My Interim Objection letter to planning application HGY/2023/1199
updated 19 July 2023

RE: 31A Riverside Road, London, N15 6DA

1. The Cover Note is provided in support of a planning application for the 'Demolition of existing single storey dwelling and construction of two storey plus basement to an end of terrace property' at 31A Riverside Road, London, N15 6DA.

Figure 5.1: Basement Floor Daylight Factor Plot

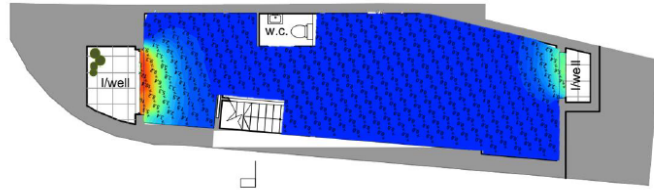
3. We must point out that the writer Mr Gunne-Jones in his cover note dated 02 May 2023 is now attempting to compare a previous layout of the basement that was refused by your department and again on appeal numerous times.

4. This is the latest comparison of Light and Layout from the New application above (HGY/2023/1199) and below we are outlining and comparing the layout with the old layout of the previous application (HGY/2021/1470) that was refused by your department and again on appeal numerous times.
- Below is from previous application HG/2021/1470

Figure 5.1: Daylight Results in the Assessed Study on the Basement Floor Level

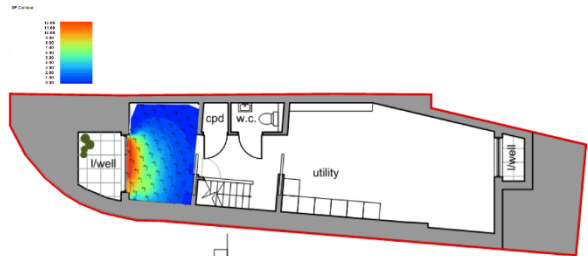
5. Note the Light and Layout information from the HGY/2021/1470 application. The utilisation of the internal space is being used for living purposes not like the new layout in paragraph 3 above. Thus, there is naturally a lack of light as the previous space is subdivided by walls and doors, cupboard and w.c. compartments and the utility area at the rear. The applicant is now attempting to compare the new scheme as outline in the plan in paragraph 3 above, (HGY/2023/1199) where the basement space is a large open space and is void of compartment space but now includes a single room indicated as "BATH and W.C" area.

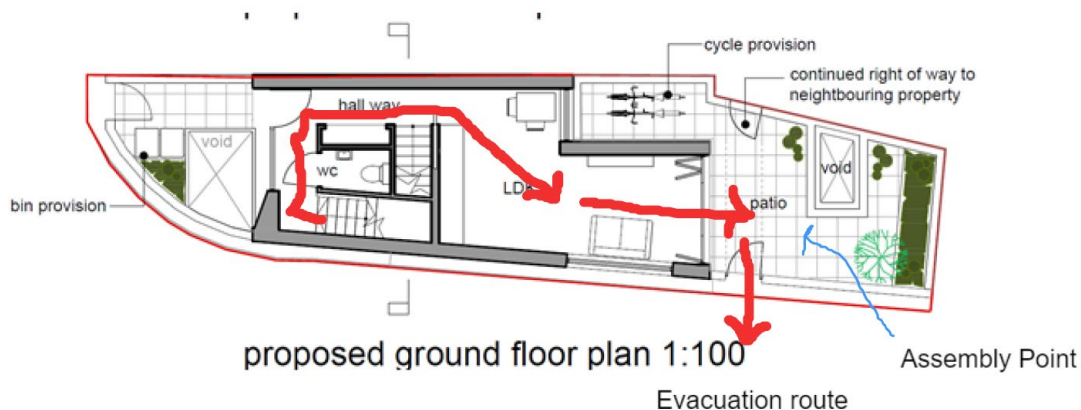
- a. How is this going to work in accordance with the application and stipulation for bins for the 4 + occupants in the 2-bedroom house?
- b. And now there is another application for an empty warehouse looking basement, with lightwells (front one takes up the bin area) but this time the bathroom space and location has changed and now stipulates a BATH and WC, with nothing else there. Who is going to believe this nonsense when it is clear that the space has to be used for living accommodation as per all the other previous failed basement applications?
